LICENSE No: 24-21362-01

ConvRec 576320

SUBJECT: Request for Additional Information (RFAI).

Reply to RFAI in Conv Rec 576320

ATTACHMENT A

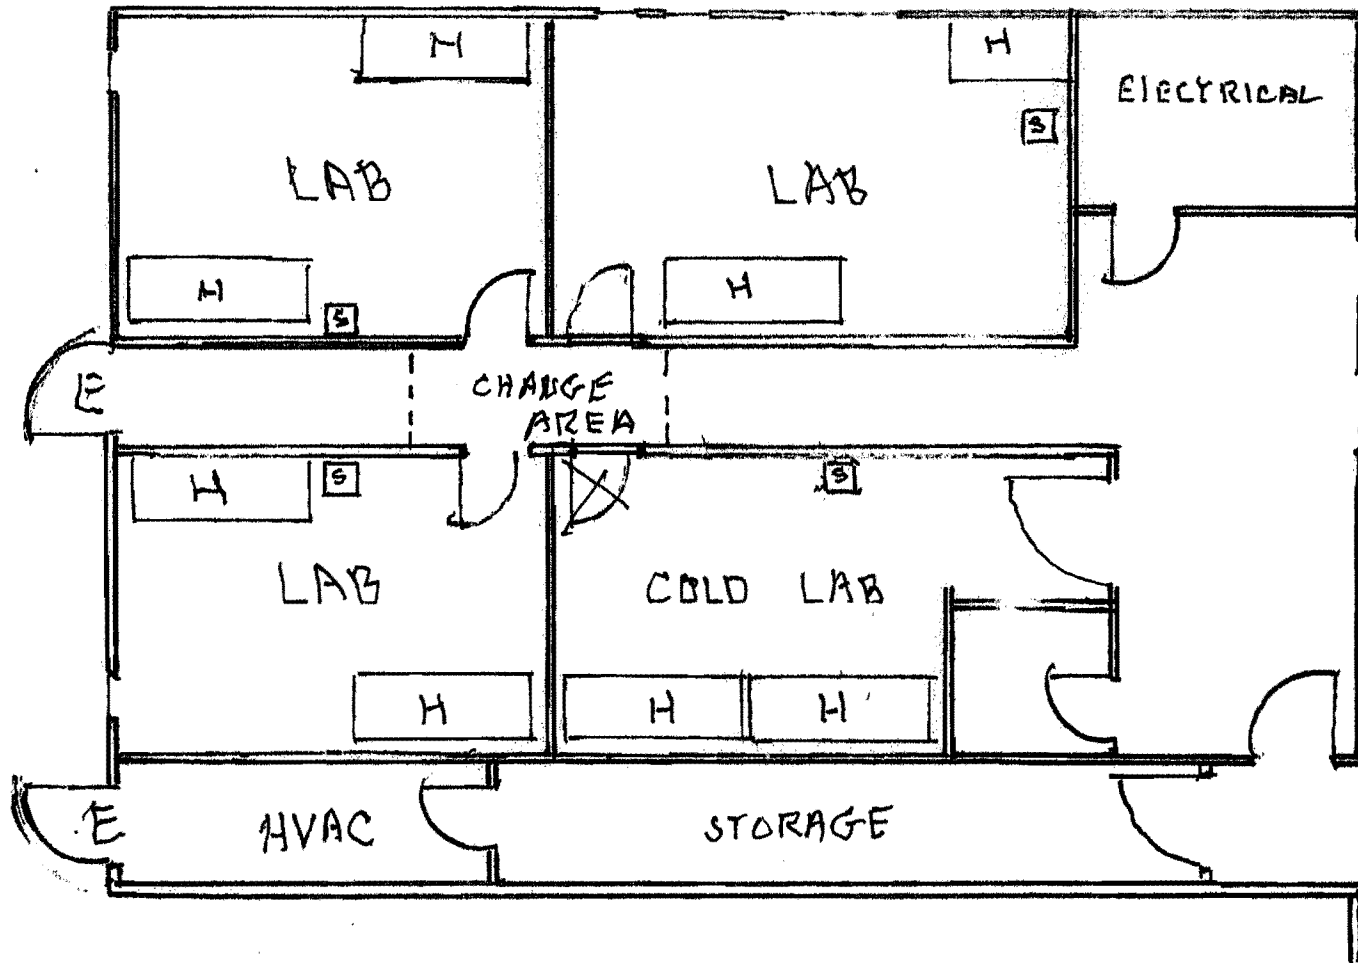
- 3. Submit a current diagram of the 300 Annex that includes both the cold and radionuclide use areas. Also, include in the diagram an illustration of the segregation between the 300 Annex and the production labs in building 300. Describe radiation safety procedures that staff will follow when exiting 300 production lab space to enter the Annex. Include specific survey procedures that will be followed in order to prevent the spread of contamination outside of building 300 production labs.**

a. See Attachment A for 300 Annex Floor Plan

b. Personnel exiting the production labs will use procedures described in ARC SOPs. They will pass through the controlled and unrestricted areas of Building 300. They will then leave building 300 to the unrestricted outdoors. They then enter the controlled area of the Annex. Entry to the purification and Analysis areas require PCE appropriate to that area. There is no way that an individual can go directly from the production labs to the labs in the annex.

ATTACHMENT B

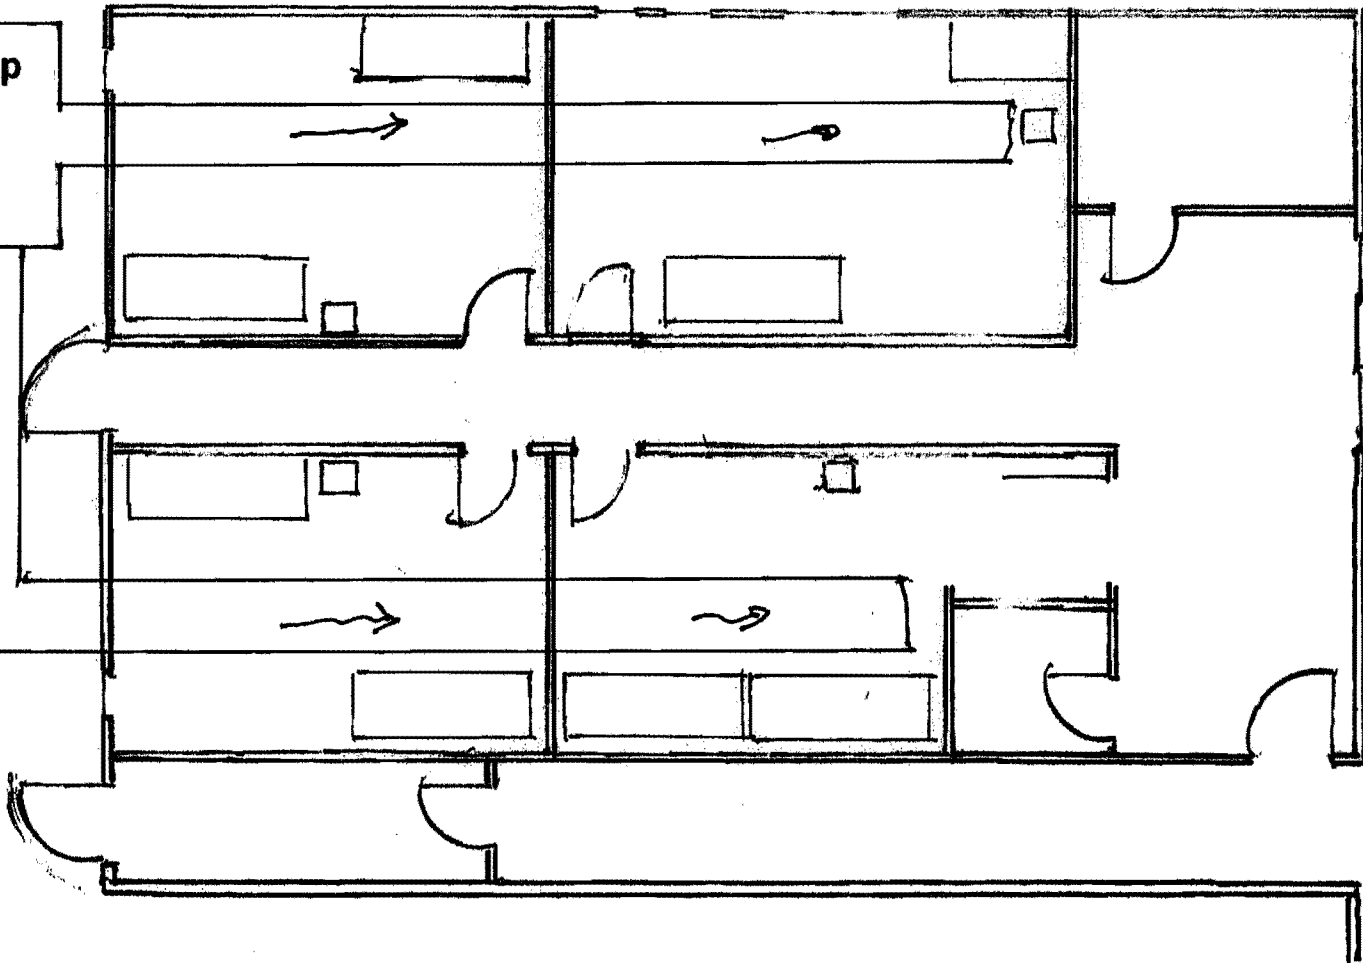
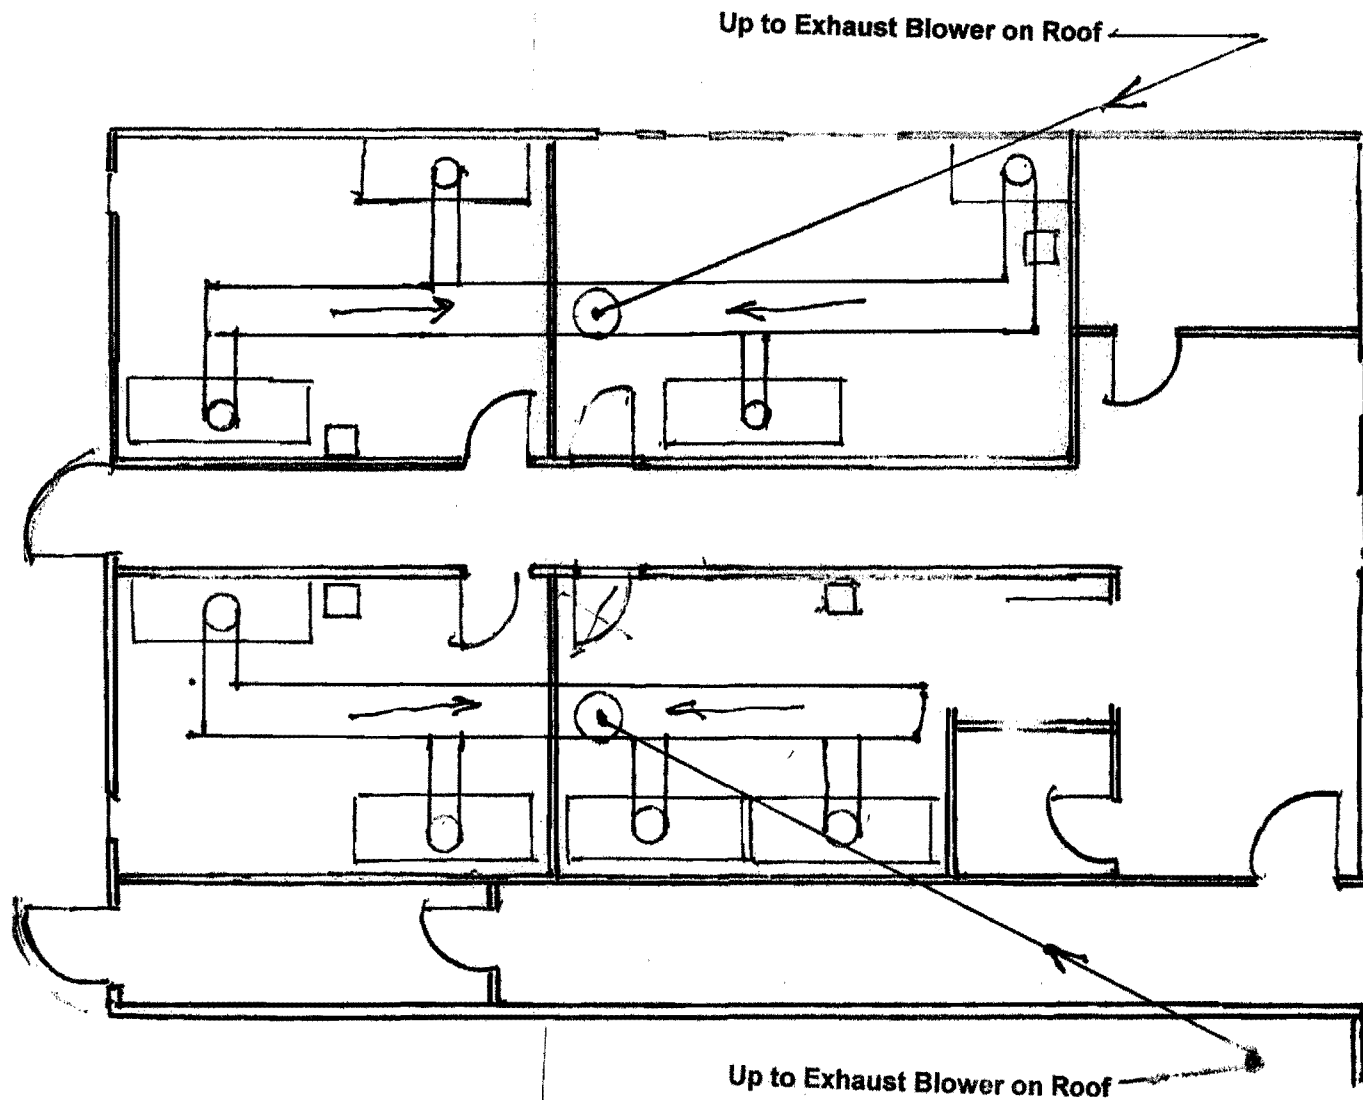
- 4. Provide a diagram of the air supply and exhaust system for the Annex. Include a description of the air flow rate that will be maintained, filtration in place (if none, please provide justification), air sampling and monitoring systems, and the air effluent release point location and height. Clarify whether or not the 300 Annex system is independent of the system that currently services the building 300 production labs.**

a. See Attachment B for supply and exhaust systems.

- b. Flow rates into each hood will be maintained at a minimum of 100 Linear Feet per Minute (LFPM). The hoods in the Annex have alarms. Set at 100 LFPM.
- c. There is no filtration in place. Filters were removed in (approximately) 2001 with NRC approval with the determination that particulate products were negligible.
- d. Air will be monitored on a 24/7 basis using the set up that is currently used in building 400. This system has been rendered redundant with the use of COMPLY for dose to the public.
- e. As can be seen from Attachment B, both the make up and exhaust air systems are completely independent fro those in use for the production labs. This attachment also provides location of the make up and exhaust systems.
